HALIFAX HARBOUR SOLUTIONS PROJECT ENVIRONMENTAL SCREENING ADDENDUM 2

**HALIFAX HARBOUR SOLUTIONS PROJECT
ADDENDUM NO. 2
RESPONSE TO FEDERAL COMMENTS**

PROJECT NO. NSD13960-6027

May 30, 2002

BARRINGTON STREET
 PLAN / PROFILE
 STA. 0+000 TO STA. 1+700
 Drawing No: HX-01-C-1002

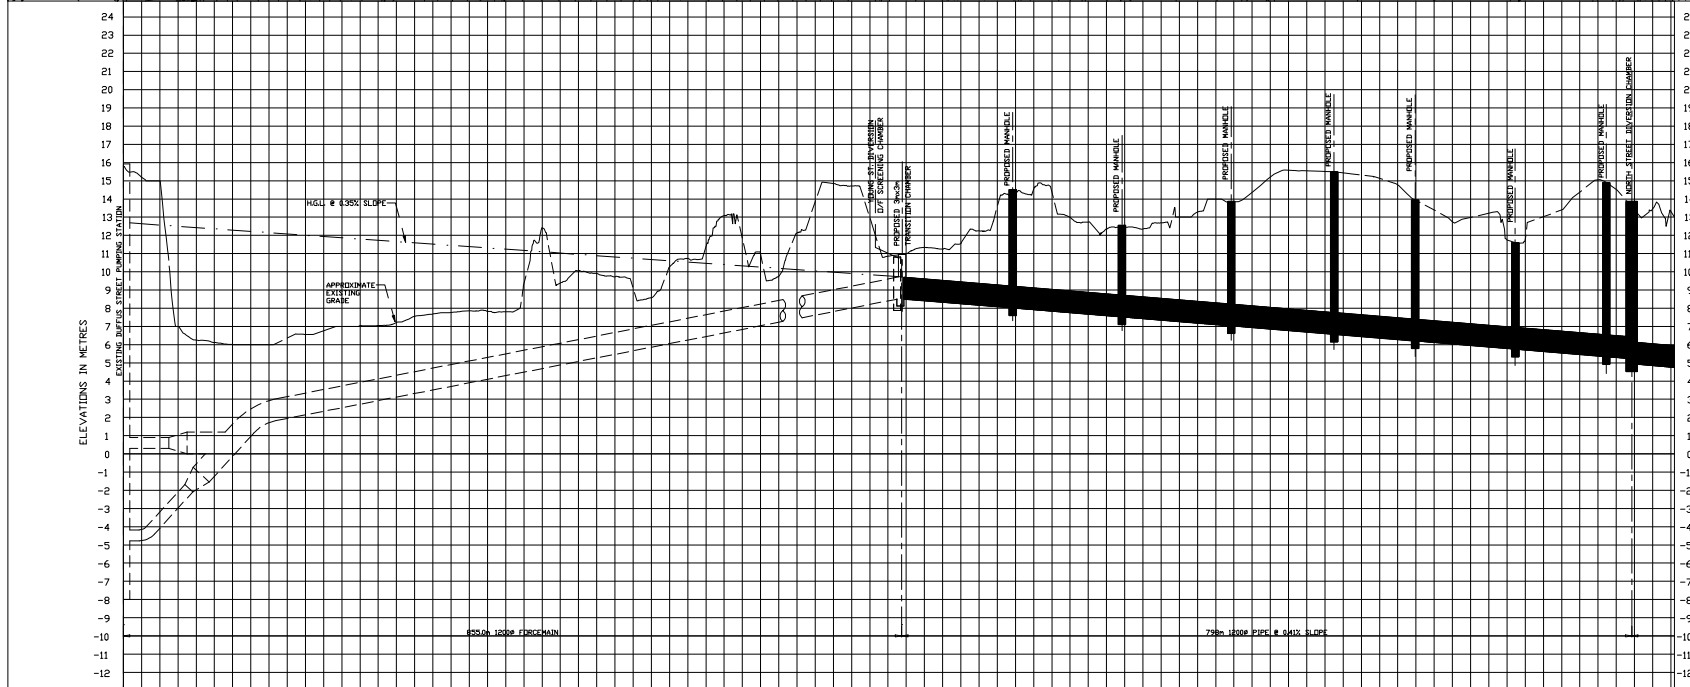
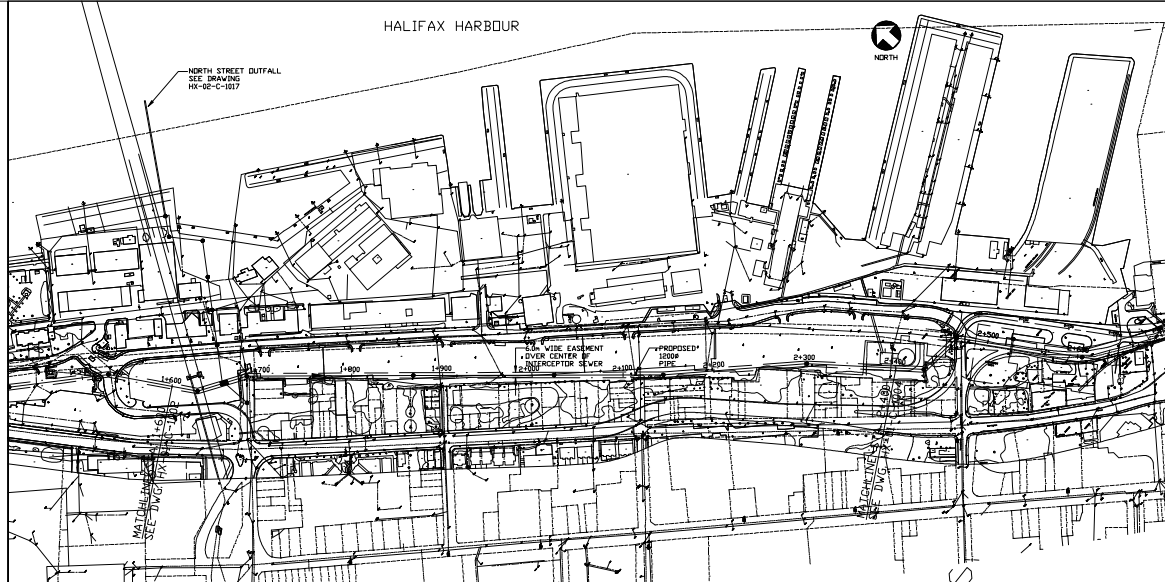
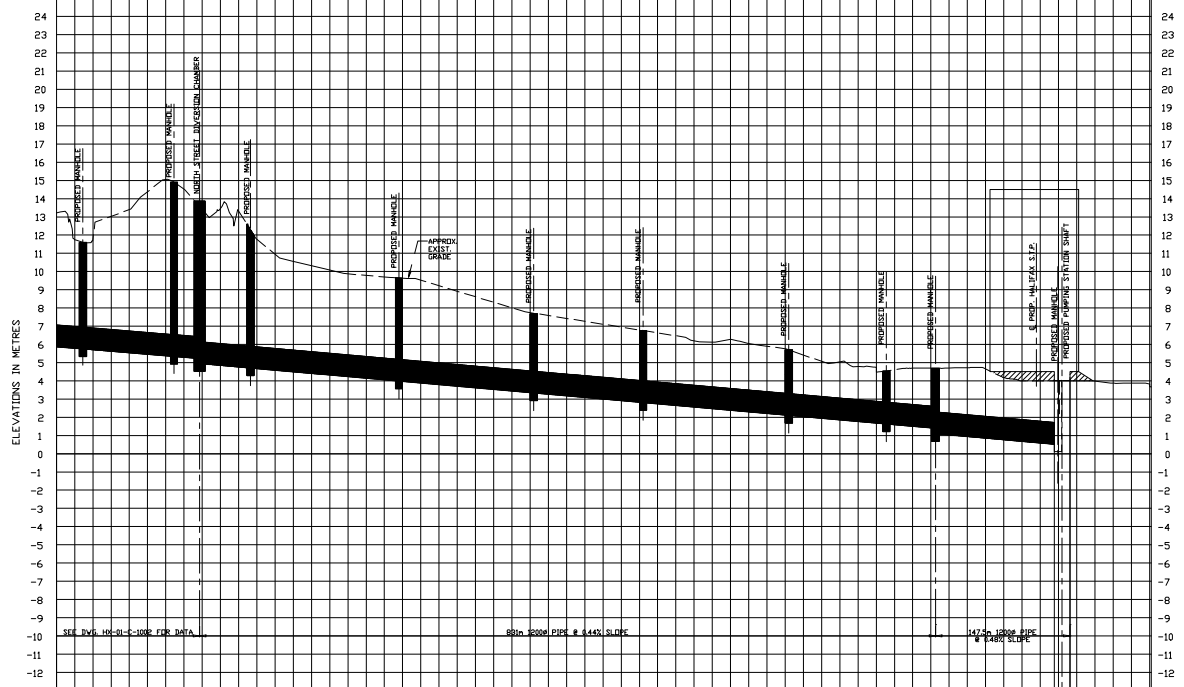
Exact location of project components on DND land is still unknown.

HREP, acting on behalf of HRM in the negotiation of easements and licenses for the HHSP project, has been negotiating with Mr. Phil M. Steeves, Manager of Real Estate Services for Maritimes Forces Atlantic, since early February 2002 for the right of way required on DND properties. As part of these discussions, HREP and DND reviewed a number of alternatives and agreed to an easement based on the requirements of both parties. A letter from Mr. Steeves dated April 19th, 2002 confirming these discussions, is provided as Appendix A.

These negotiations have included discussions on the location of the necessary sewer line required by HRM. Since then several changes have been made to the proposed routing at DND's request. The attached drawings (HX-01-C-1002 and HX-01-C-1003 in Appendix B) detail the latest version of this routing; it is HREP's understanding that this routing is mutually acceptable to both DND and HREP. Similarly, the requirements for siting the Jamieson Street Pumping Station and diversion piping are shown on attached drawing DT-01-C-2007 (amended to show only the Jamieson Street works) (Appendix B). A letter of intent between DND and HREP is presently being finalised.
